Office Action Summary

10/534,364

DETAILED ACTION

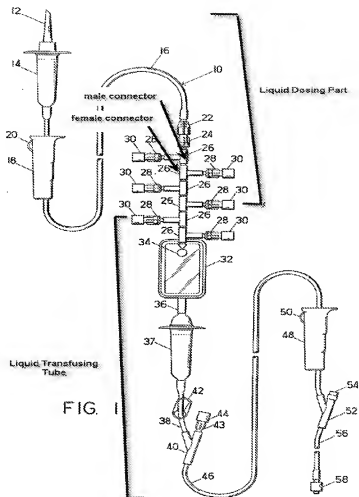
Regarding claims 1 and 5-10, Gula et al. discloses a liquid transfusing assembly (Figure 1) comprising: a tube constituting a liquid transfusing channel (fluid channel from element 26-46); a connector (26) provided at one end part of said tube; and a connection part (opposite side of element 26) provided on the other side of said tube and connected to the side of a containing part containing a transfusion (connected to spike 12); wherein said connector includes a male connector and a female connector (tee spike distal/proximal ends (26)), and the axis of said male connector and the axis of said female connector substantially coincide with each other (along longitudinal axis of center of tee spikes 26); and a liquid dosing part (assembly from 12-upper tee connector 26) for dosing a patient with said transfusion, said liquid dosing part having a liquid dosing part side connector (upper tee 26) capable of being connected to one of said male connector and said female connector of said connector of said liquid transfusing tube (46-26); wherein in the condition where one of said male connector and said female connector of said connector of said liquid transfusing tube and said liquid

dosing part side connector of said liquid dosing part are connected with each other, the other of said male connector and said female connector of said connector of said liquid transfusing tube can be connected to a liquid transfusing tube other than said liquid transfusing tube (Figure 1, see marked up figure below).

Gula et al. further discloses the liquid dosing part having a bacteria-removing filter (32, col 3, ln 55-65) provided on the downstream side relative to said liquid dosing part side connector; wherein said liquid dosing part has a mixing injection port (43) on the downstream side (defined as fluid flow from 12 to 58) of said bacteria-removing filter (32); and wherein said liquid dosing part side connector is branched into a plurality of parts (tees 26) so that a connector provided on the other end side of a tube having on its one end side a connection part connected to another liquid container (tee ends 28) other than said liquid container and said connector of said liquid transfusing tube can be simultaneously connected (Figure 1, col 3, ln 30-55, see marked up figure below).
